THIS DRAWING IS:  
 APPROVED  
 APPROVED AS NOTED  
 RETURNED FOR CORRECTION  
 RESUBMIT

TRACO STEEL INC.			
SANDY SPRINGS, S.C. 29677			
PROJECT: <b>ANDREWS JR. HIGH ADDITION</b>	DATE:		
LOCATION: <b>ANDREWS, N.C.</b>	REVISED:		
DWG. COVERS: <b>ROOF FRAMING PLAN</b>	APPROVAL: <b>1-29-75</b>		
ARCHT. OR ENGR.: <b>ERIC TOWNSON</b>	FIELD USE:		
CONTRACTOR: <b>BUNCOMBE CONSTR.</b>	SHOP:		
SHOP NOTES:	SHOP PAINT:	HOLE SIZE:	
DRWN. BY <b>W.S.T.</b>	JOB NO.:	DRWG. NO.:	
CHK. BY:	<b>9-1(6)</b>	<b>E-1</b>

ROOF FRAMING PLAN

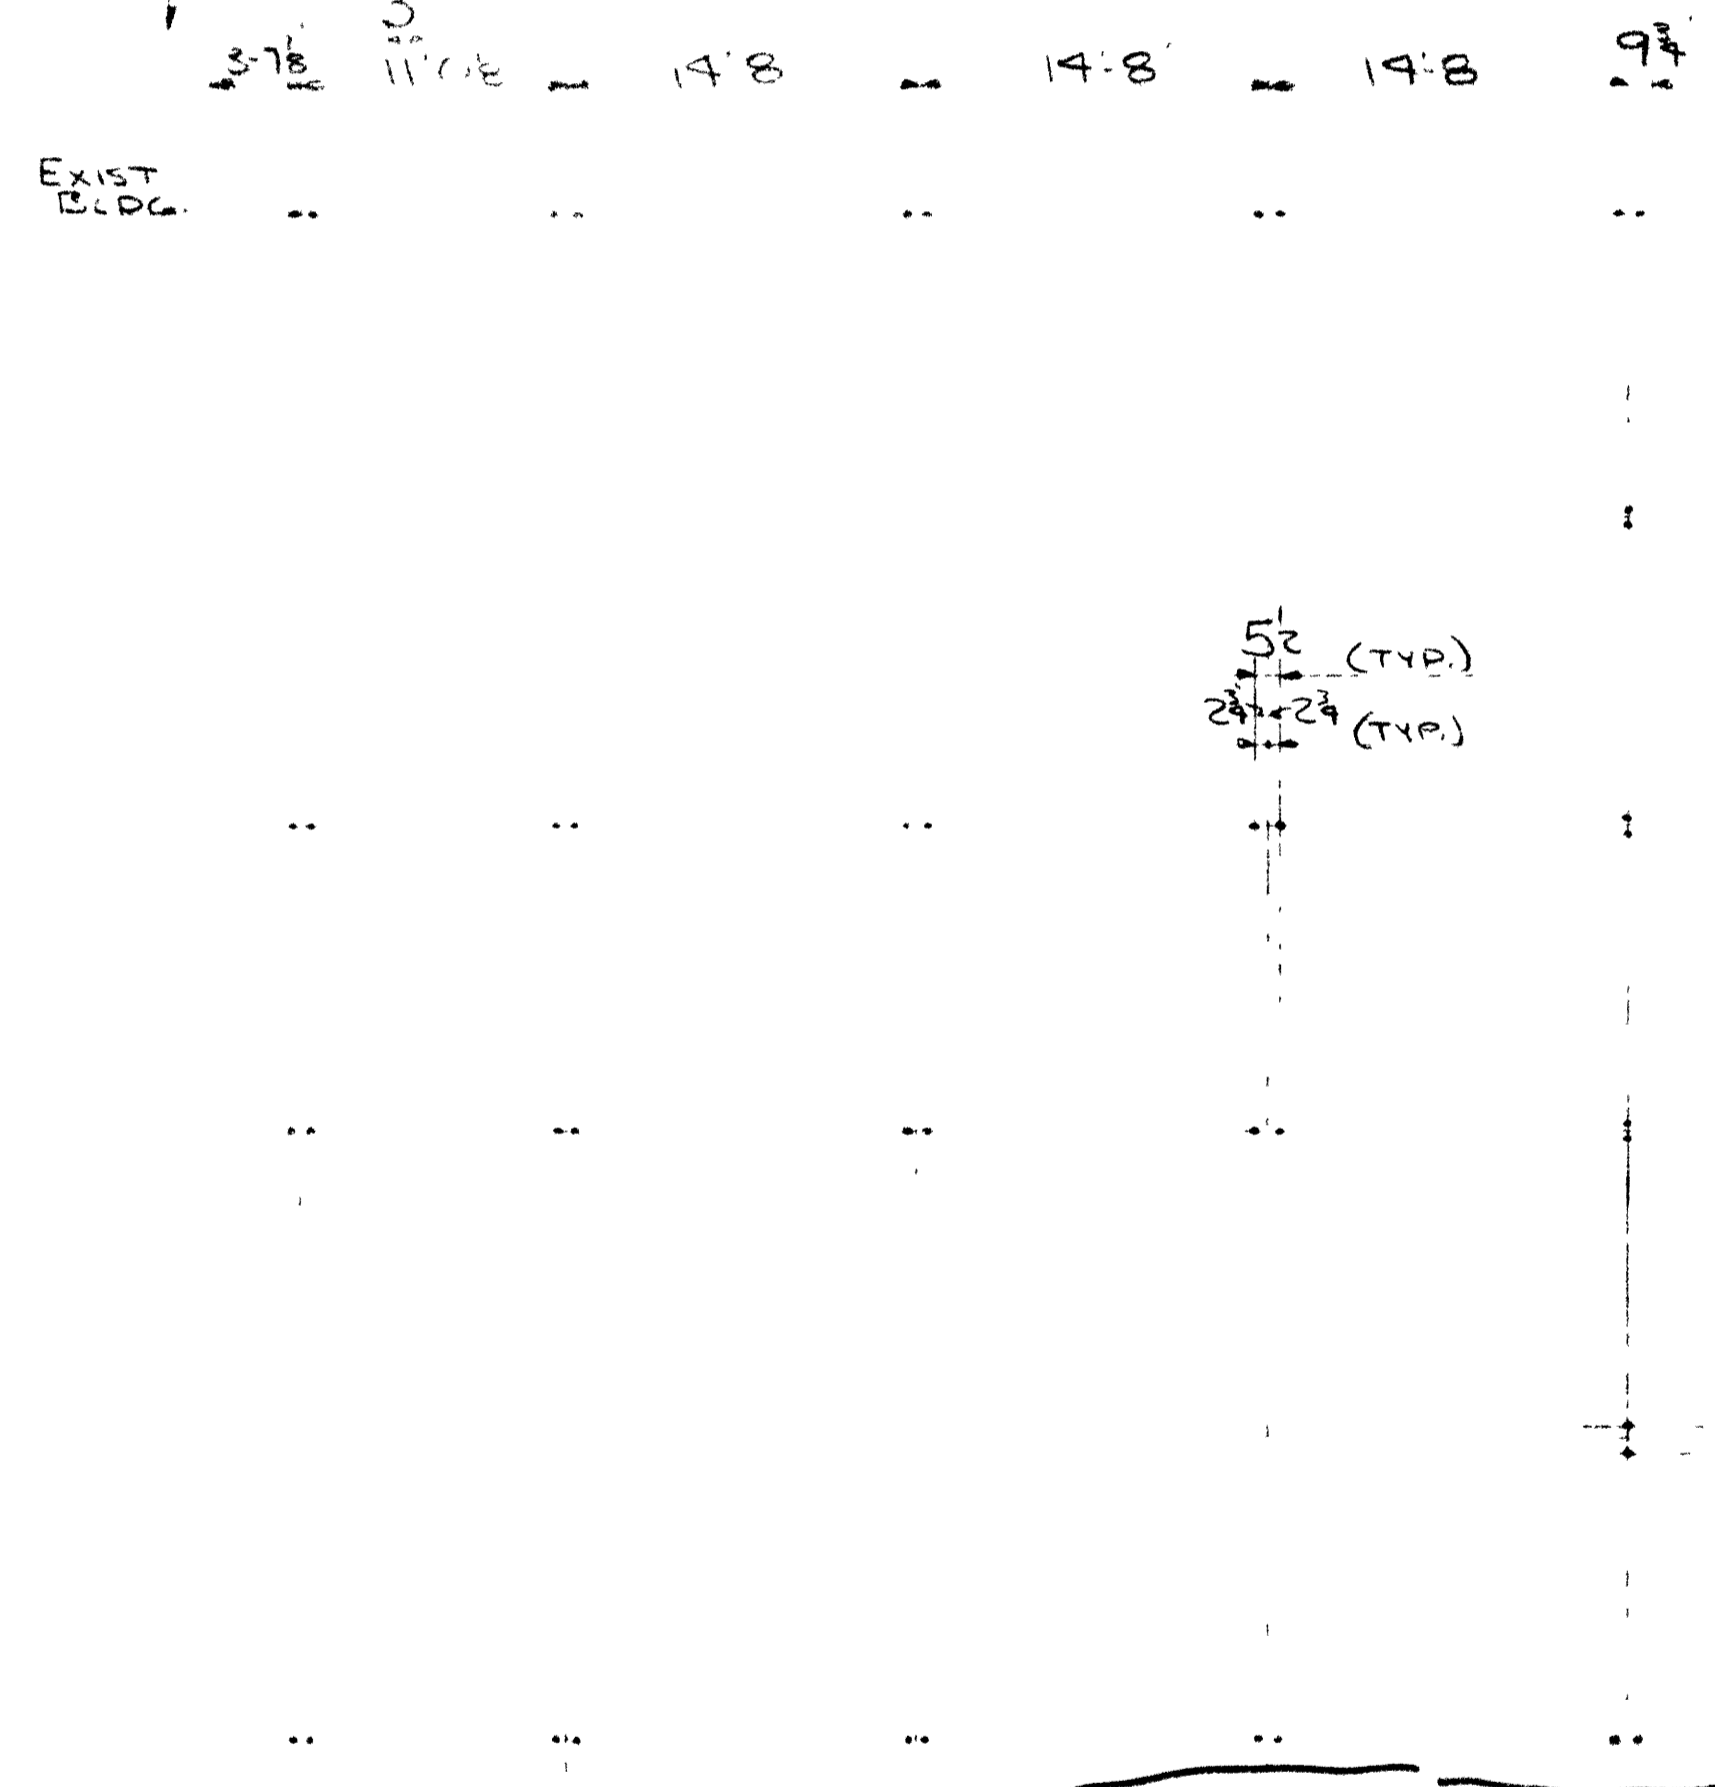
MATERIAL O.K., SUBMIT COMPLETE MANUFACTURERS WELDING INSTRUCTIONS FOR APPROVAL. SEE SPECS.

TYP. BEAM SPLICE (IF NECESSARY)

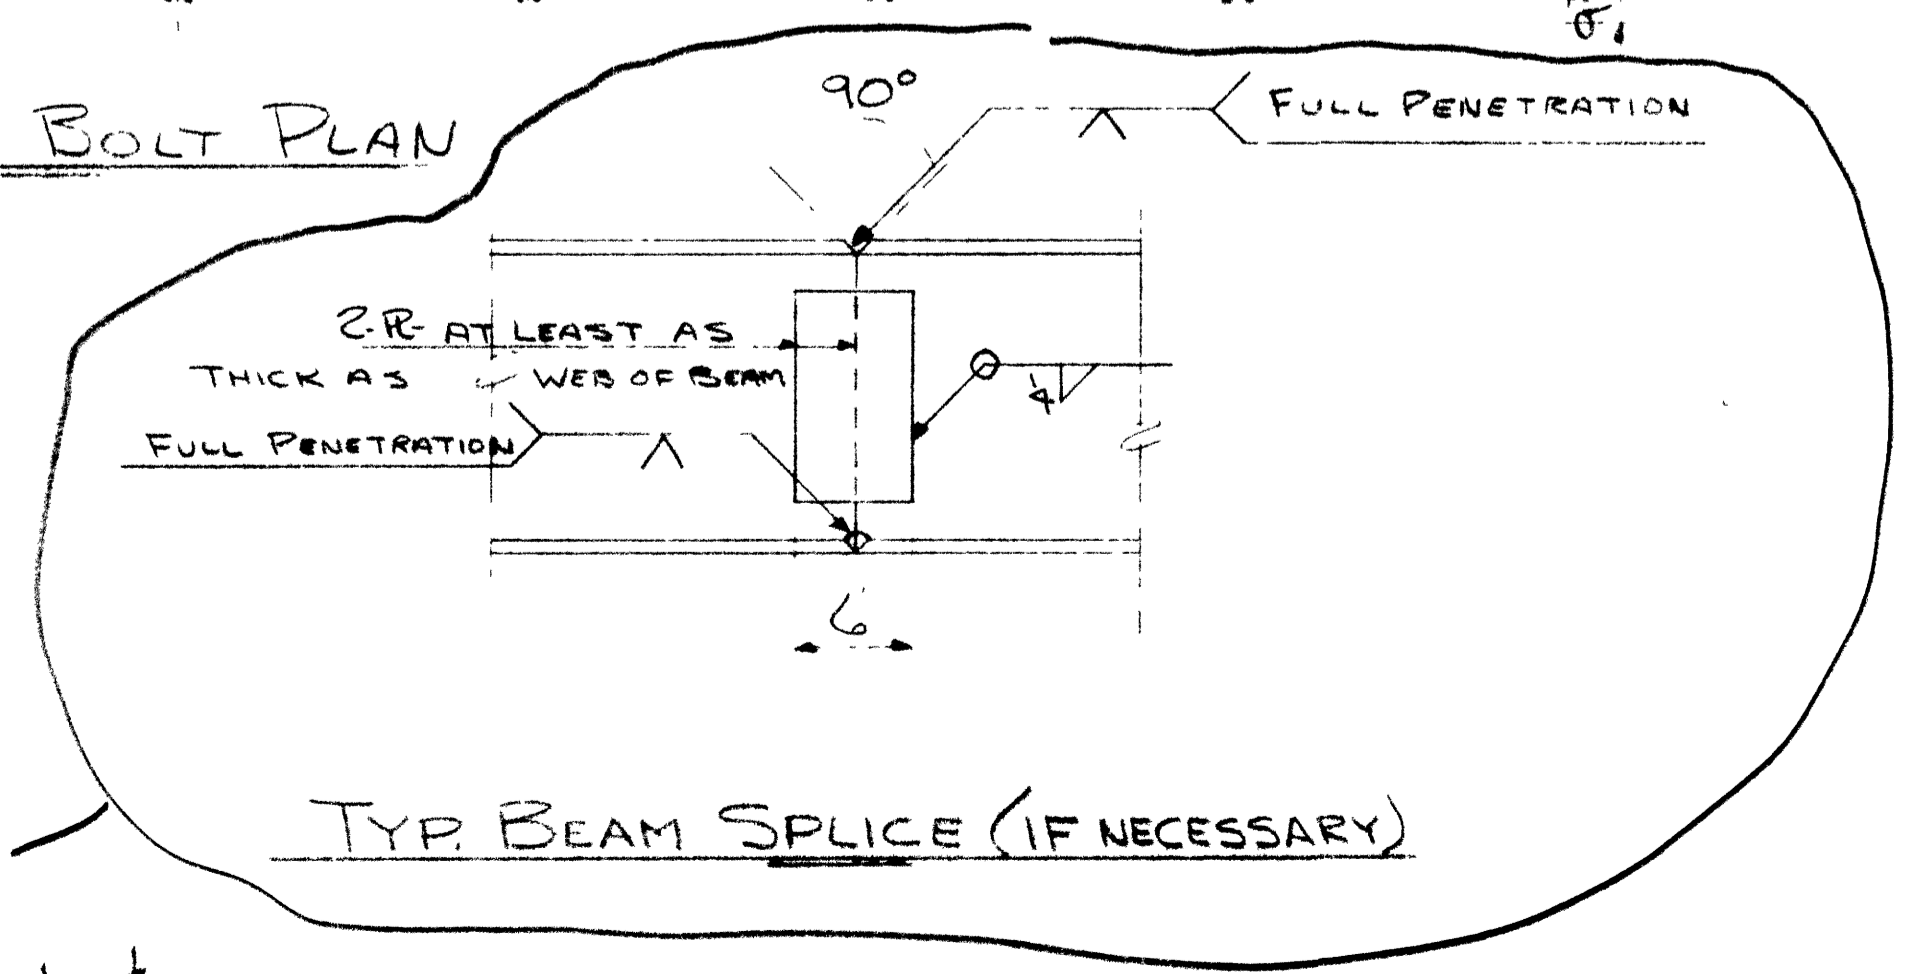
NOT ACCEPTABLE! INDICATE EACH SPLICE LOCATION & SUBMIT FOR APPROVAL
